CITY PLANNING COMMISSION

- APPLICATION:**
1. Environmental Determination
 2. Rezone 16± vacant acres from Agricultural (A) and Highway Commercial (HC) to the Townhouse (R-1A) zone
 3. Tentative Map (Subdivision Ordinance)
 4. Special Permit to develop 56 zero lot line and 60 halfplexes (Sec. 7-C, Zoning Ordinance)
 5. Subdivision Modification to create reverse frontage lots (Sec. 40.326, Subdivision Ordinance)

LOCATION: Southwest corner of Bell Avenue and Taylor Avenue

PROPOSAL: The applicant is requesting the necessary entitlements to develop 111 zero lot line and halfplex units and to create two parcels for future commercial development.

CONCEPTUAL SITE PLAN

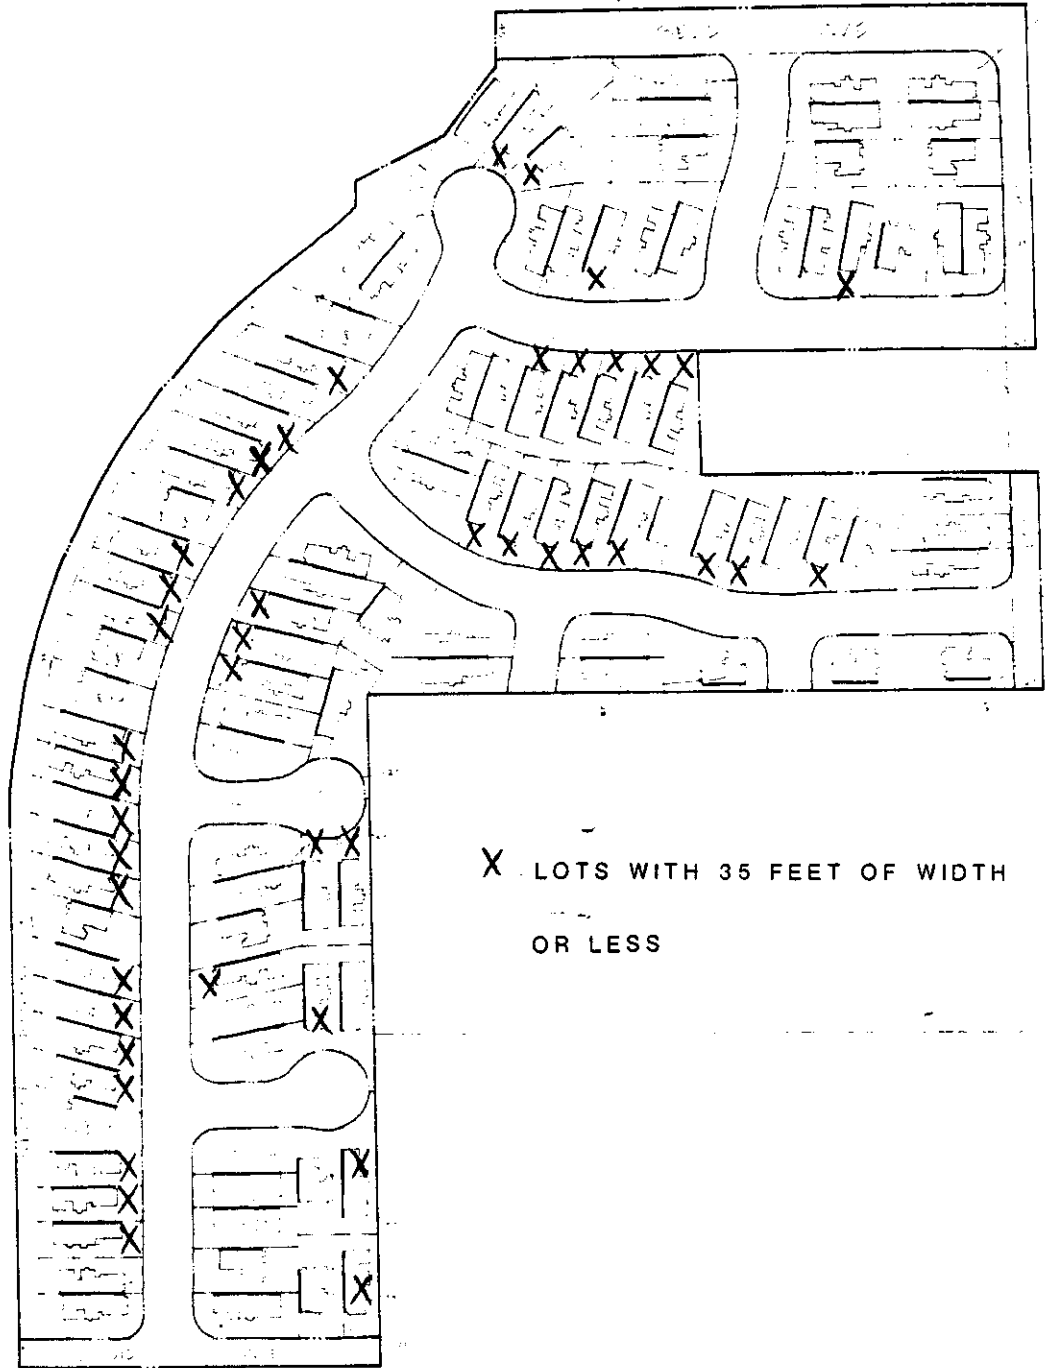
4. Although staff has no objections to the concept of developing the site with zero lot line and halfplex units, staff does have concerns over the design of this project. Forty-one of the proposed zero lot line lots in this development are 35 feet wide, four lots are 30 feet wide or less and because of the narrow lotting pattern the structure design is limited. As proposed, 83% of the units are only 25 feet wide which limits the possibility of solar access for a majority of the north/south oriented lots. The narrow lots have also created a situation where the minimum setback between zero lot line units is less than 10 feet, which has been the standard minimum setback approved for this type of development. This proposal indicates that the maximum setback achievable between some of the units is only 7-1/2 feet. A condition has been placed on the map to require a minimum of 10 foot setback between units, which may further reduce the width of some units.

6. As proposed, the applicant's plans indicate dual street frontage for two of the lots along Bell Avenue. The applicant proposes to develop these two sites with back-on lots which is contrary to the proposed residential design criteria for development adjacent to major streets. Staff has recommended these lots be redesigned using the proposed design criteria for subdivisions located on major streets. The applicant has, however, indicated that modification is not possible for these lots due to grading variation of the drainage ditch along Bell Avenue. The City Engineer indicated that front-on lots with access on Bell Avenue would not be possible due to the grading variation and close proximity to the bridge.

7. The applicant needs to propose major changes in an effort to gain staff support for the halfplex and zero lot line development. Staff recommends expansion of the lots to a minimum width of 45 feet. The roof lines should be changed to provide more variety on front elevations. In addition, the units should be widened to accommodate more exposure of the living area to the street.

1. Ratification of the Negative Declaration;
2. Recommend denial of the Rezone;
3. Recommend denial of the Tentative Map and Subdivision Modification;
4. Denial of the Special Permit, based upon findings of fact to follow:

REVISED
 ELEVATIONS
 1 MAR 84

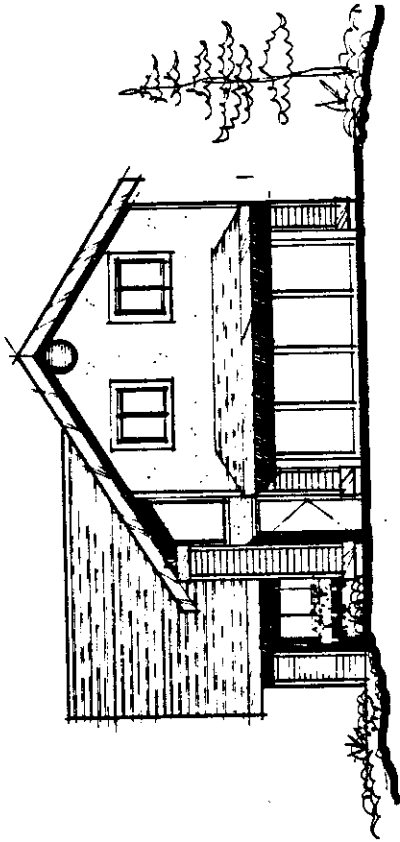
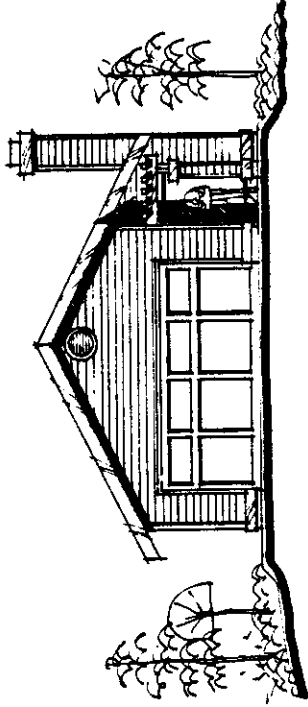
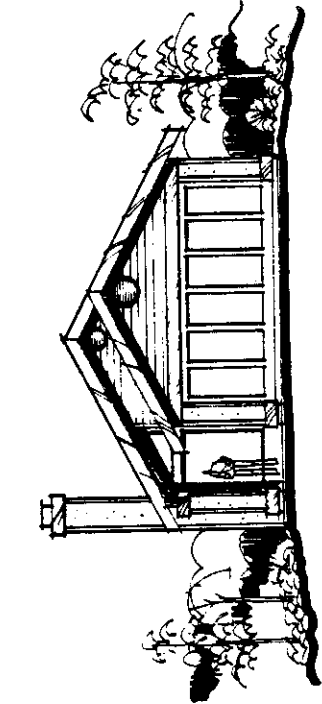
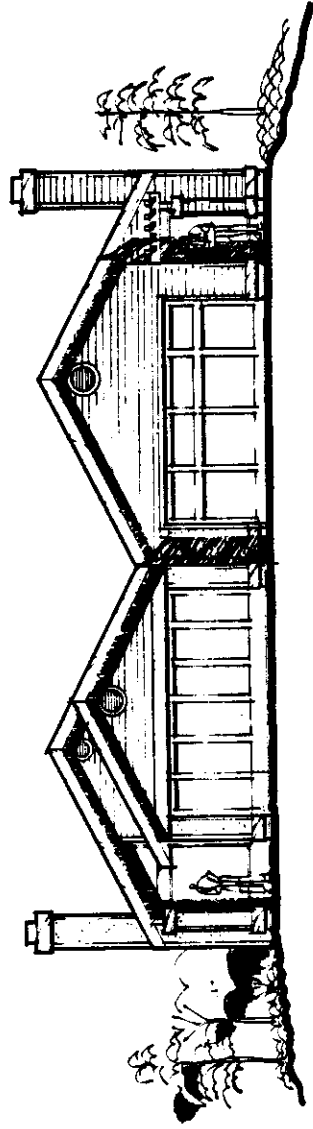
5. Staff also has concern over the design of the structures. As proposed, the 25 foot wide units will be developed with little or no unit orientation on the street other than the garage. The predominance of garage frontages will create a monotonous streetscape and adversely affect the design of the neighborhood. In addition, the lack of street oriented units may create future security problems in that the living area of the structure will be isolated from the street and prevent the resident from monitoring neighborhood and street activity. In an effort to address staff's concerns over the structure design, the applicant submitted revised plans. In reviewing the applicant's revisions, staff finds no discernable difference between these plans and those originally submitted. The floor plans are substantially the same and the predominant feature on the front elevations are the garages.
